February 19, 2021
412 Blvd of the Allies Office Build-Out
IFB #600-01-21

ADDENDUM NO. 7

This addendum issued February 19, 2021 becomes in its entirety a part of the Invitation For Bid IFB #600-01-21 as is fully set forth herein:

3 IDF T27 - RACK ELEVATION
T2.02 SCALE: 1" = 1'-0"

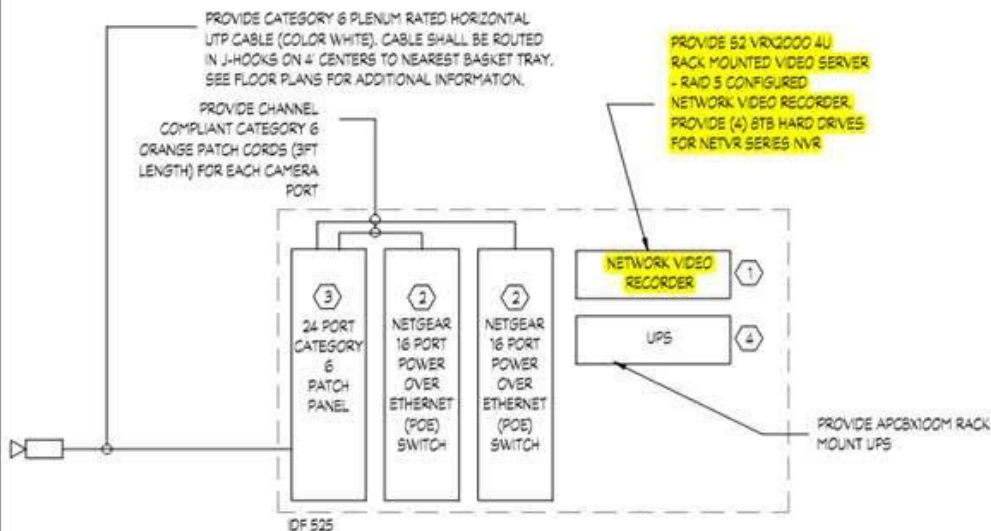
Item 16: Q: I'm sorry to keep bugging you on this but I wanted you to understand why I was asking about this. There appears to be some discrepancies in the documents. It would appear that they are asking for a switch to be provided by the security contractor for the cameras. It also appears that the owner is supplying their data switch. Also a different (727) IDF is indicated on this as well. It should read 525 if it is to match the drawings. I hope this information helps you get some answers.

A: **Switch for cameras shall be provided by the owner. See Addendum #7, Item #20 below. The CATV headend shall be in 5th floor IDF as shown on security drawings.**

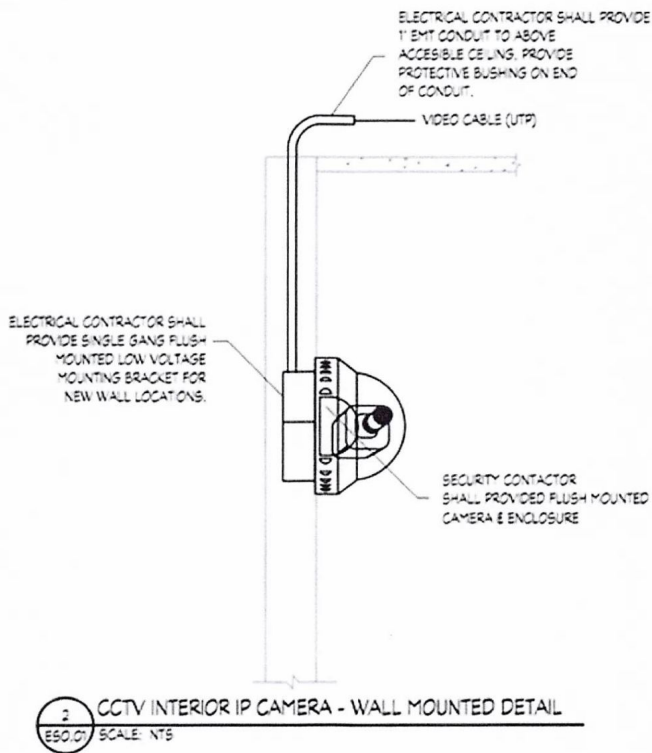
Item 21: Q: Video system- the camera schedule on ES2.02 states “PROVIDE WALL MOUNT W/ JUNCTION BOX AND PENDANT CAP” for all wall mount cameras. However, the camera drawings show the cameras just being mounted to the wall without any type of mount or pendant cap. Can you further clarify? I do not want to add cost if it is not needed. Screen shot below for reference.

A: **Wall mount and pendant caps required for all wall mounted cameras.**

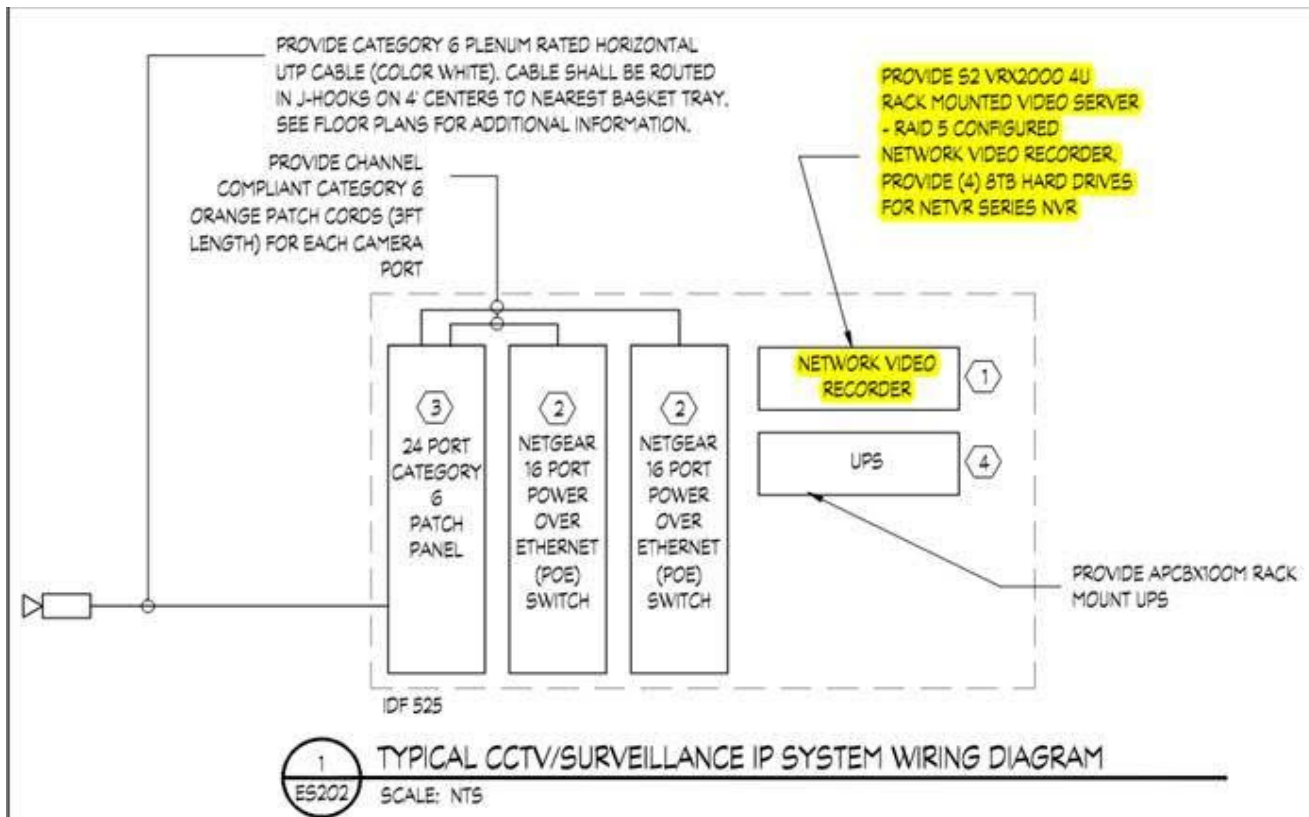
Item 22: Q: Also the NVR states that the VRX2500 to be a 4U unit and is not available in a 4U configuration and only a 2U configuration is available. It is likely an error but wanted to bring light to it. The 2U VRX2500 is what we will be quoting unless they change the model to a 4U model with an appropriate model number to match. This is a pricey part and I need to be sure that we are quoting the correct one.

A: Correct part is VRX2000 and is only 2RU.
